## RECALL: "TANGO" connector incorrect marking

mod. KONG TANGO # 715.000

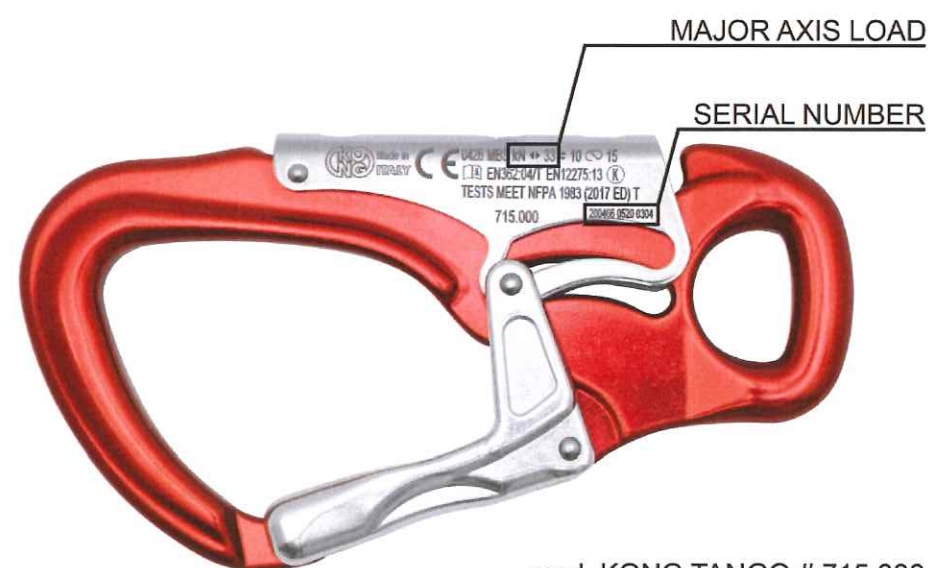
During our quality control procedures, we identified incorrect markings of the strength rating along the major axis with the gate closed on two batches of the connector model "TANGO".

The connector shows an incorrect value of 50kN instead of the correct strength rating of 33kN.

Improper marking may lead users to apply a load up to 50kN causing possible breakage of the connector, that is tested to a maximum load of 33kN.

### HOW TO CHECK THE DEVICES

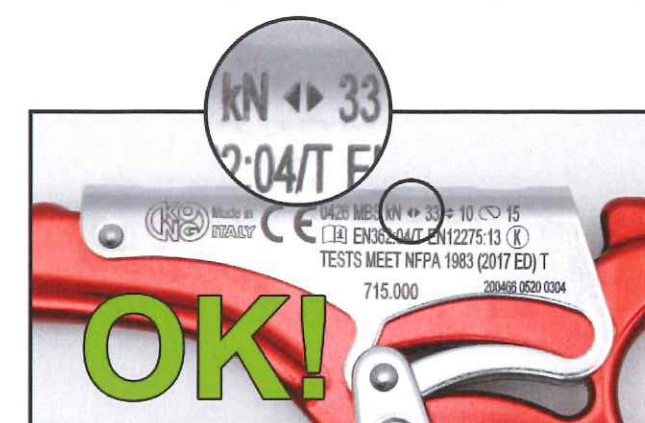
Verify that the strength marking along the major axis with the gate closed is 33kN.

Below the examples of correct marking, and wrong marking.

In order to avoid any possible misuse (i.e. overloads), the connectors with the wrong marking (50kN) shall be taken out of service, and replaced.

KONG will collect and replace the connectors with others of the same model, but correctly marked (33 kN).
